Subject: RE: Utica River bridge - causeway hydraulics

Subject: RE: [External] IL 178 over Illinois River - Worst Case Scenario Model

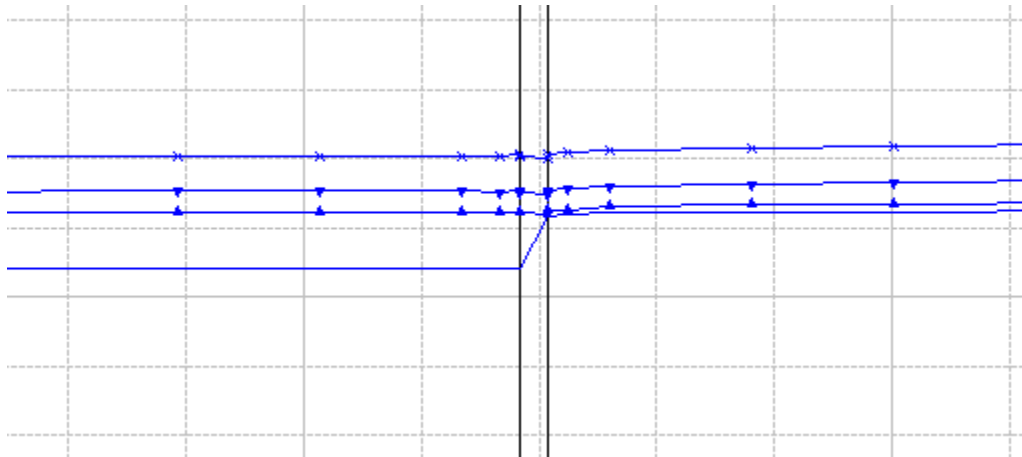
Please note that the surveyed WSE in April was 450.94 ft which was used to calculate the EWSE, however this run shows the effect of removing part of the causeway in anticipation of a flood.

The above summary reports the worse for the 50 and 100 year storms. For Q10 there is a significant created head at the bridge for the less obstructive scenarios as illustrated below. I corrected this by applying Yarnell instead of Momentum equations for Q10.
